# London Luton Airport Expansion

**8.68 Applicant's response to Written Questions -  
Biodiversity**

Application Document Ref: TR020001/APP/8.68

<b>Deadline:</b>	Deadline 4
<b>Planning Inspectorate Scheme Reference:</b>	TR020001
<b>Document Reference:</b>	TR020001/APP/8.68
<b>Author:</b>	Luton Rising

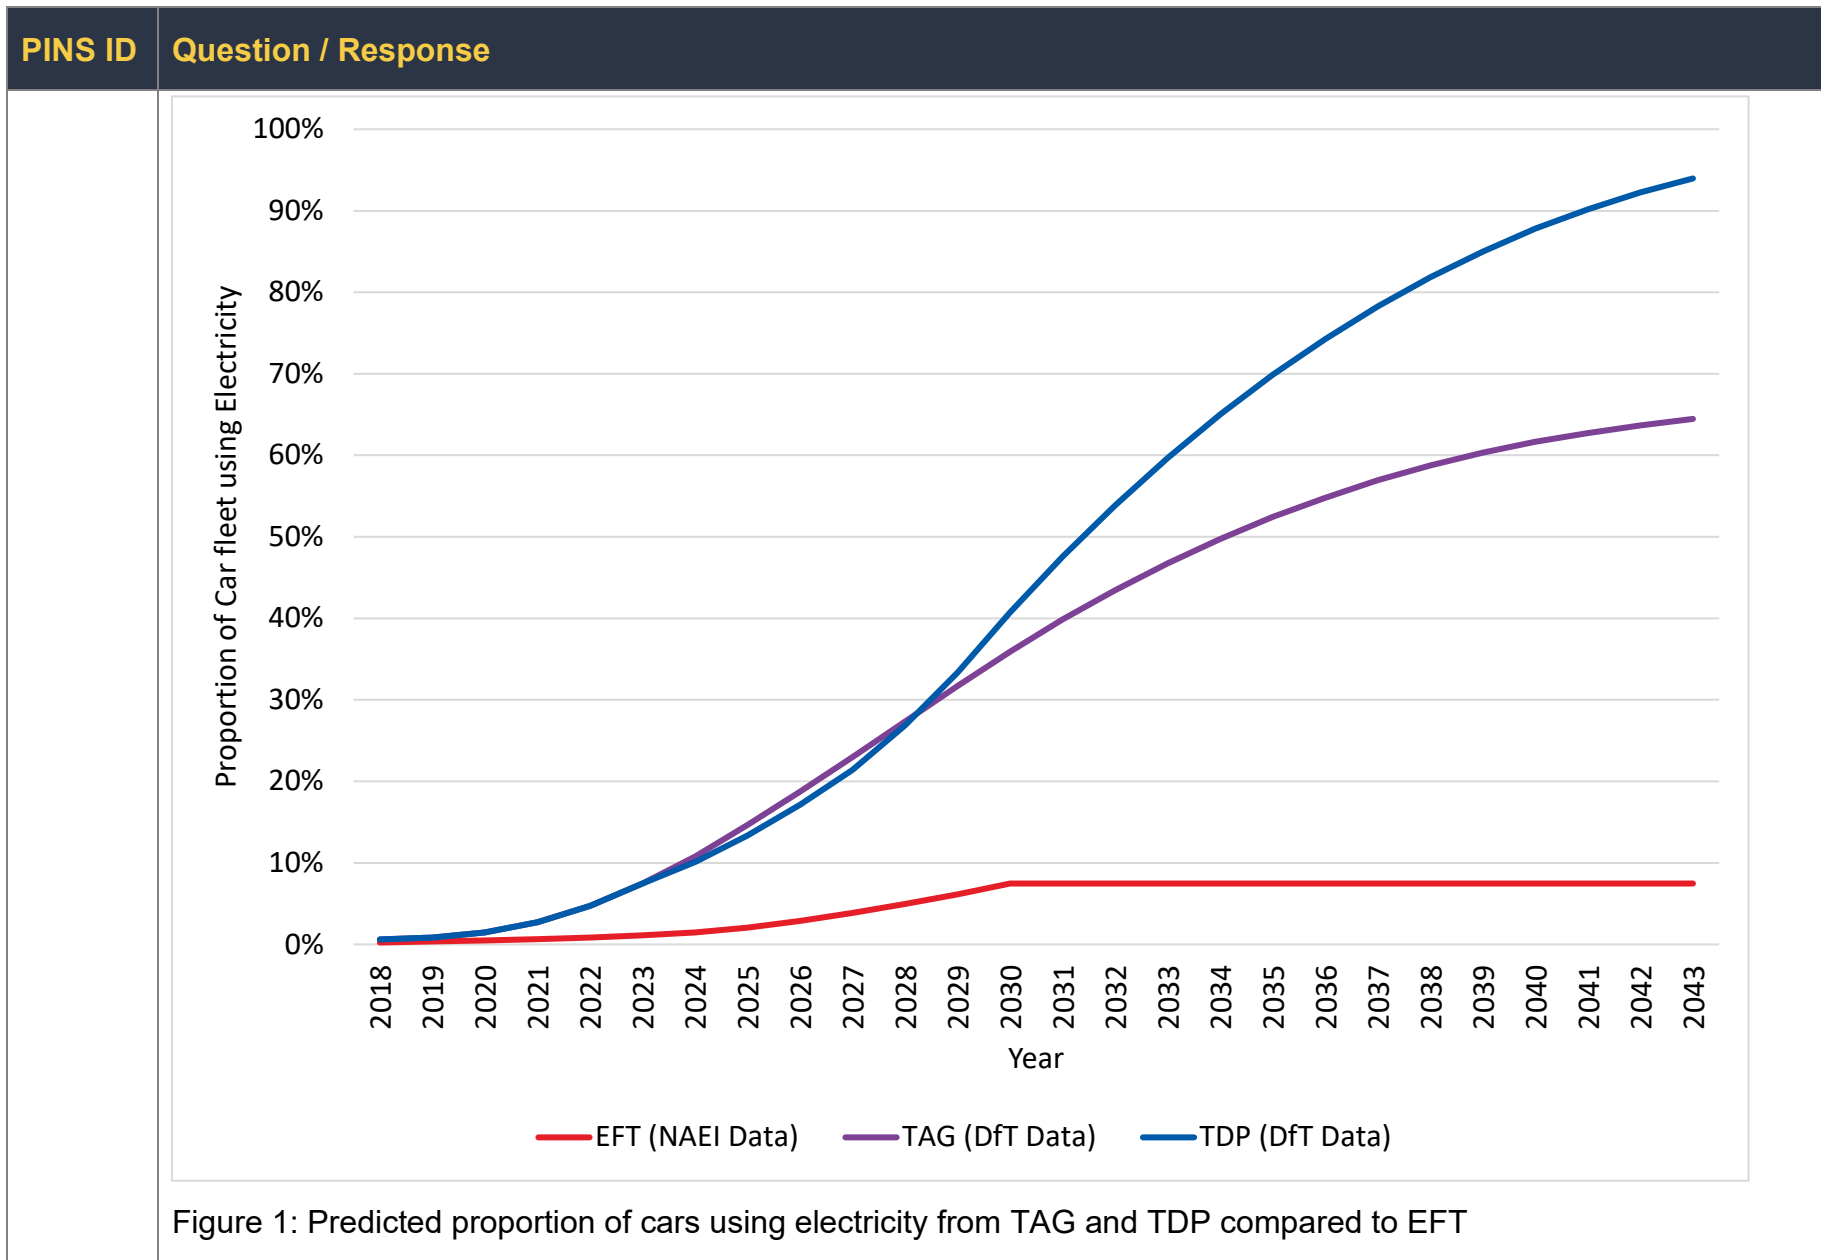
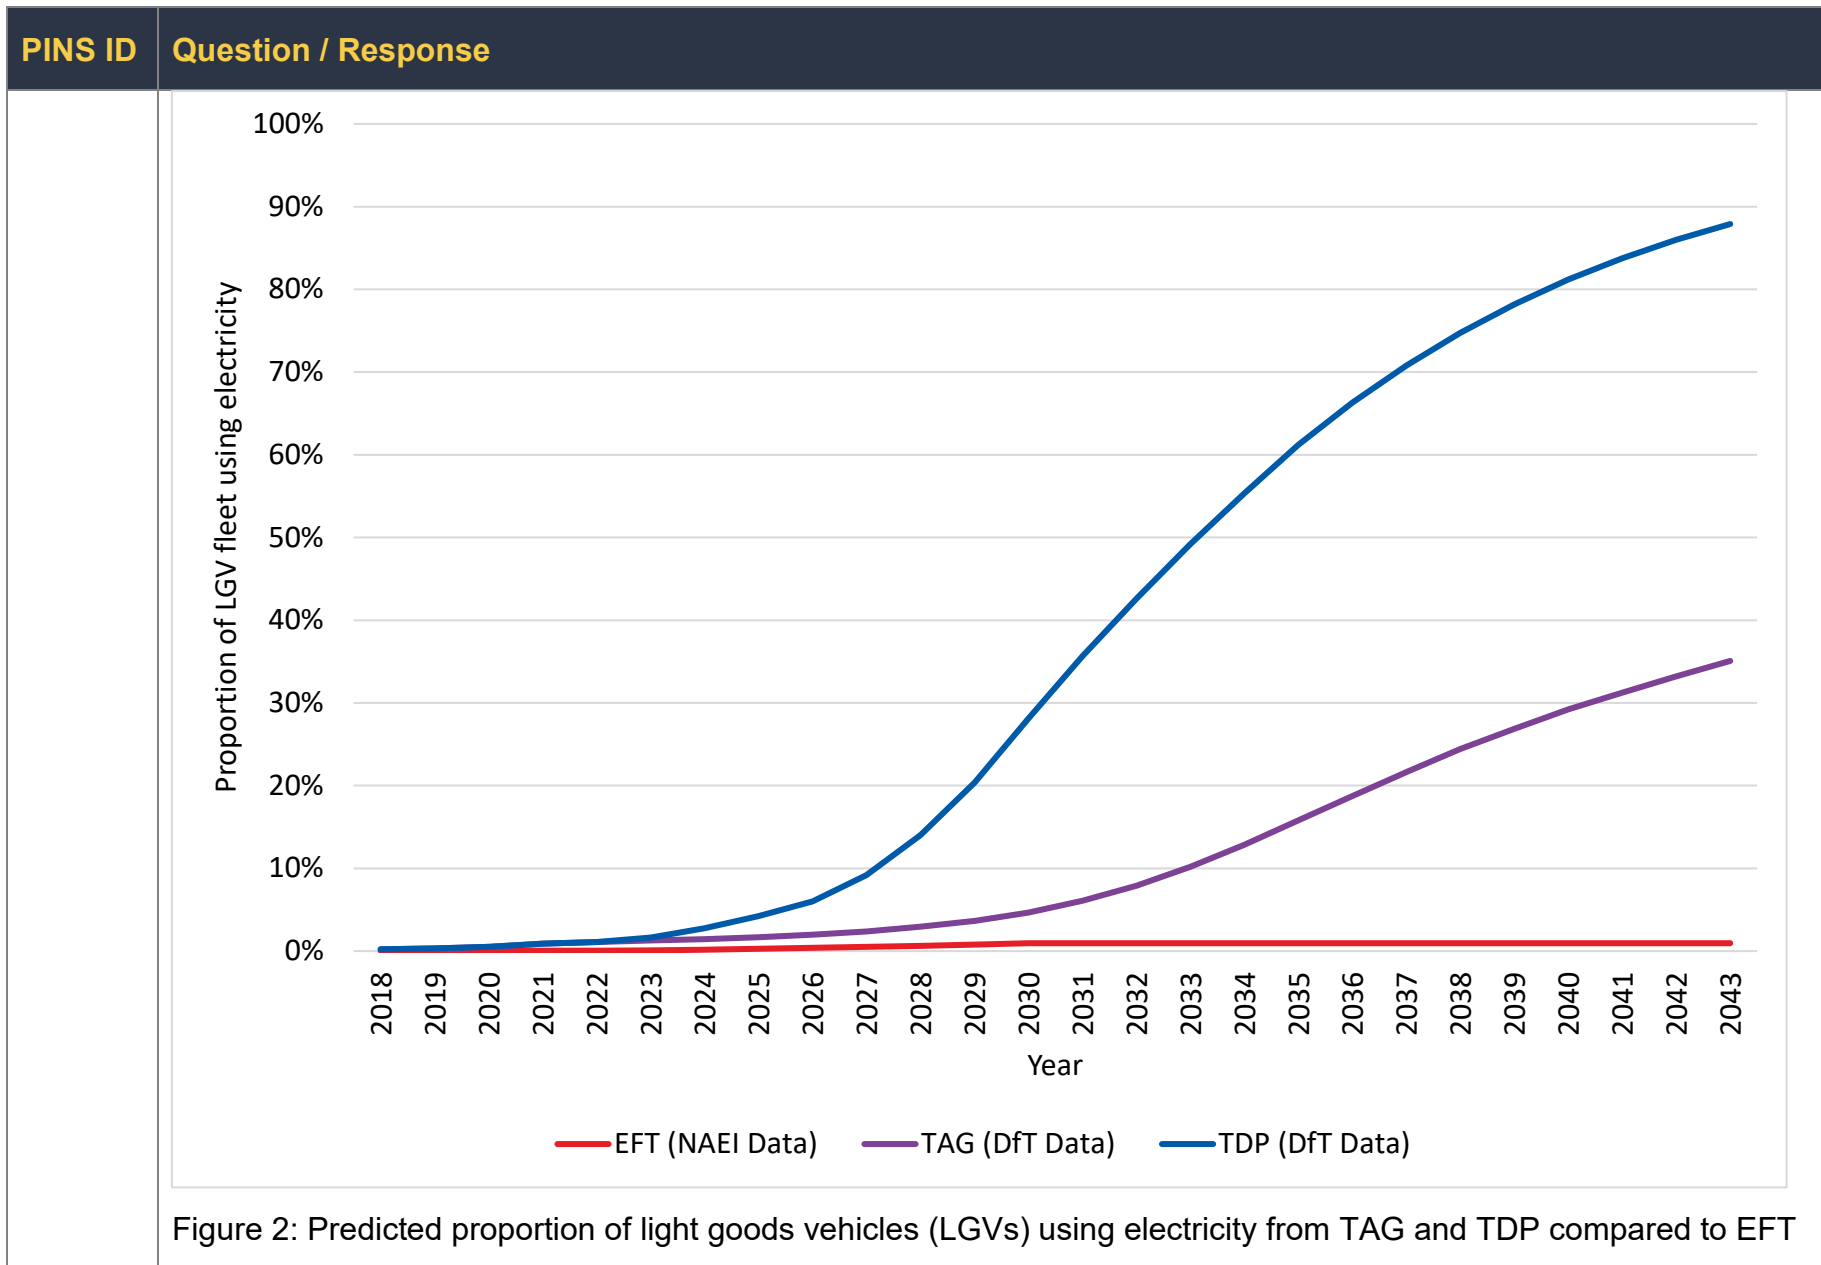
PINS ID	Question / Response
BIO.1.1	<p><b>Question:</b>  <b>Orchids</b>                      The mitigation strategy for orchids [AS-035] relies in part on an existing orchid population beyond Wigmore Valley Park County Wildlife Site. It is not clear from the information provided [AS-033 and AS034] where existing stands of orchids across the site are located. Please provide this information in a level of detail sufficient to inform a site inspection.</p> <p>At ISH6 and in the Applicant's response at D3 [REP3-053] it is stated that <i>"there have been many examples of natural colonisation [of orchids] occurring very quickly in close proximity to the proposed site"</i>. Provide the evidence to support this statement.</p> <p><b>Response:</b>                      Please see an additional Figure created in response to this question [LLADCO-3C-ARP-00-00-DR-YE-0262] that shows the location of all orchids identified during baseline surveys for the Proposed Development. It should be noted that in some locations, such as grassland 5 north of Winch Hill Wood, orchids were very frequent (around 200 common spotted orchids noted) and growing widely in the open sward. Thus, precise location of individual plants is not provided, rather associated habitat parcels are indicated. Further details of these results are provided on pages 9 and 10 of the <b>Appendix 8.10 Ecological Mitigation Strategy Orchid and Invertebrates [AS-035]</b> and within <b>Appendix 8.1 Ecology Baseline Report of the ES [AS-033]</b>.</p> <p>Regarding the comments made around local orchid colonisation, at ISH6 these were made primarily in reference to the species noted during baseline surveys for the Proposed Development, including the common spotted orchid colony in grassland 5. Section 2.6.177 of the <b>Ecology Baseline Report [AS-033]</b> reports Grassland 5 has also been taken out of agricultural use and has been colonised by a range of agricultural associated species with patches of bare ground, including the orchids.</p>

PINS ID	Question / Response
	<p>Additionally, the lead biodiversity witness for the Applicant (Dr Paul Clack) formerly worked for the Herts and Middlesex Wildlife Trust. This included management experience at local nature reserves. The Trust manages Hexton Chalk Pit, around 5km north of Luton Airport. This is a site where various orchid species including those found within the Wigmore Park County Wildlife Site (CWS) have colonised a former active chalk quarry, with young plants frequently found on the thin exposed soils. Additionally, common spotted orchid colonised exposed chalky gravels at Stocker's Lake, also managed by the Herts and Middlesex Wildlife Trust.</p> <p>Harrop and Harrop (2005)<sup>1</sup> report that pyramidal orchid takes readily to man-made habitats, including abandoned industrial sites and disused quarries, and is one of the first orchids to move into such newly created habitats. They also report that bee orchids occur on similar sites as pioneer species and behave “...like ‘weeds’, colonising areas of bare or disturbed ground. They increase rapidly in numbers until a closed sward develops and then, being ‘poor’ competitors, they disappear.” They also report that this species is tolerant of heavy grazing and trampling.</p> <p>Orchids within the CWS are assumed to have colonised naturally on the former landfill site from wind-blown seed from the wider area. It should be noted that within Section 4 of Appendix AA to the <b>Ecology Baseline Report [AS-035]</b> it was noted that the lack of regular livestock grazing at Wigmore Park means that Bramble and expanding rhizomatous patches of introduced Michaelmas-daisy are, and will continue to be, a threat to the extent and quality of herb-rich neutral and calcareous vegetation.</p> <p>The Applicant has control over land in the new open-space and the ability to specifically manage newly created, enhanced and retained habitats for orchids and other species. Through the detailed design stage, final habitat management prescriptions will be refined and further input from LBC and HCC ecologists will be welcomed. Paragraph 10, sub paragraph 1, of Part 2 of Schedule 2 of the <b>draft DCO [REP3-004]</b> includes a suitable control measure, making provision for the landscape and biodiversity management plan to be approved by the relevant planning authorities.</p> <p>There is opportunity to review seed sources and mixes through the detailed design stage. Although not currently proposed, seed from orchids including common spotted and pyramidal orchid can be included in bespoke seed mixes and is available from seed merchants. Orchid seeds are very small and light, and such seed does not form significant percentages in proprietary mixes but could be added into the mix to be sown in discrete locations if required.</p>

Figure 3: M1 emissions example

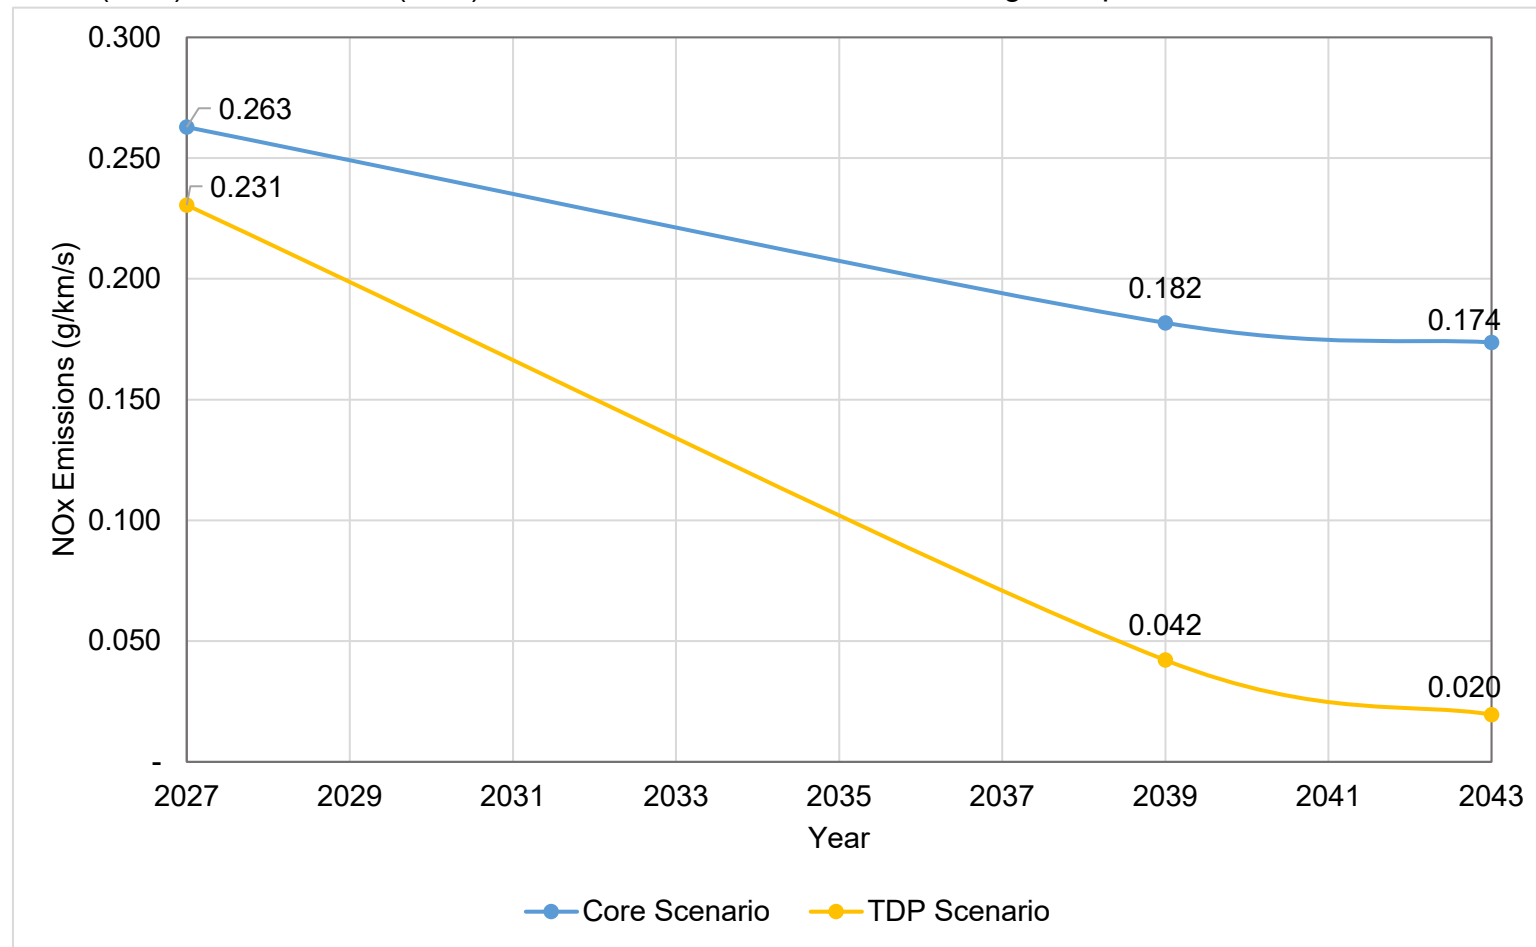
BIO.1.3	<p><b>Question:</b>  <b>Nitrogen deposition</b>          At ISH6 and in the <b>Applicant's response at Deadline 3 [REP3-053, paragraph 3.1.19]</b> it is stated that agriculture is a significant source of nitrogen and that the proposed removal of land from agricultural production would counterbalance the modelled nitrogen deposition on protected habitats and species.</p> <ol style="list-style-type: none"> <li>1. Provide an assessment, ideally quantitative, of the anticipated reduction in nitrogen deposition from removal of agriculture and the associated timescales for this.</li> <li>2. Provide the equivalent assessment of the anticipated reduction in nitrogen deposition from the shift to electric vehicles referred to in <b>[REP3-053, paragraph 3.1.21]</b>.</li> </ol> <p>The results of the air quality modelling in <b>Appendix 7.3 [APP-063]</b> and mapping of these <b>[AS-099]</b> are noted. However, the plans are not clear in respect of ecological receptors because cross-referencing is still required with the results tables. Please provide clear illustrations for the different phases of modelling of:</p>

A comparison of emissions calculated for a stretch of the M1 has been undertaken to provide a quantitative example of the implications of the different predictions of EV uptake. Figure 3 provides the data from this example, which demonstrates that the air quality assessment approach using the EFT is more conservative with respect to nitrogen oxide (NOx) and ammonia (NH3) emissions, which contributes to nitrogen deposition.
